Development Review Team (DRT) Comment Form

Case No.: Case #2024-7752 - 4000 & 4200 Beckner Rd. Meridian Preliminary Serial Subdivision Plat

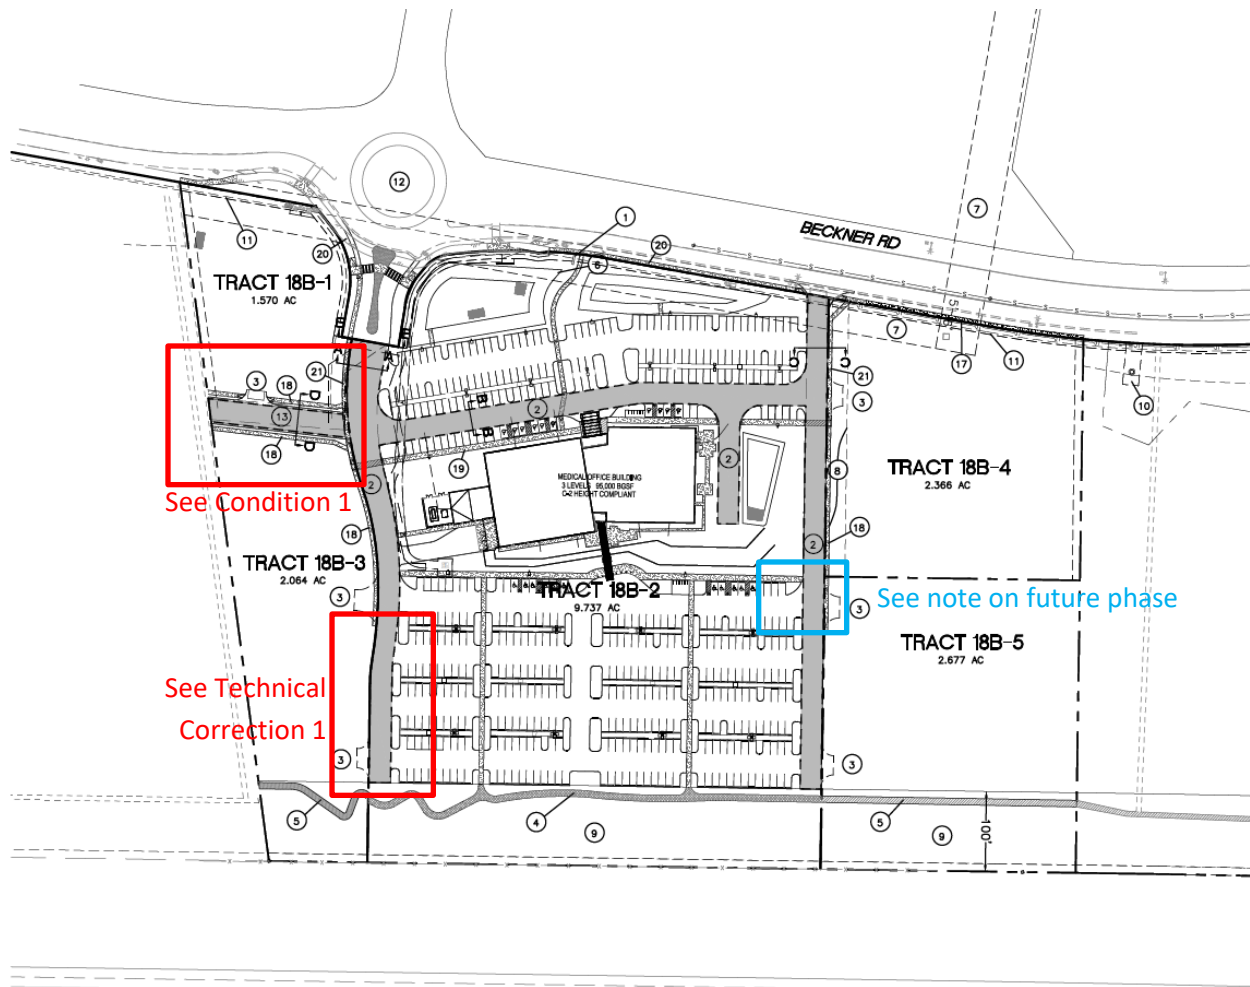
Conditions of Approval:	Must be completed by:	Applicant Response**:
1. Street cross-section D-D should reflect current City design practices of 10' vehicle travel lanes and 6' sidewalks	Prior to public hearing	
2.		
3.		
4.		
5.		
6.

The street design criteria in Chapter 14 are based on average daily traffic. While this is unavailable for the proposed street shown by cross-section D-D, it is unlikely the daily traffic will exceed 5,000. The collector street type or sub-collector is probably more appropriate which has 10' vehicle travel lanes instead of 11'. Additionally, the City has been increasing the standard size of sidewalks across the city to 6', such as in the nearby Paseo del Sol design for Tierra Contenta Phase 3. The lane reduction can be shifted to the sidewalks to match this standard without increasing street right-of-way.
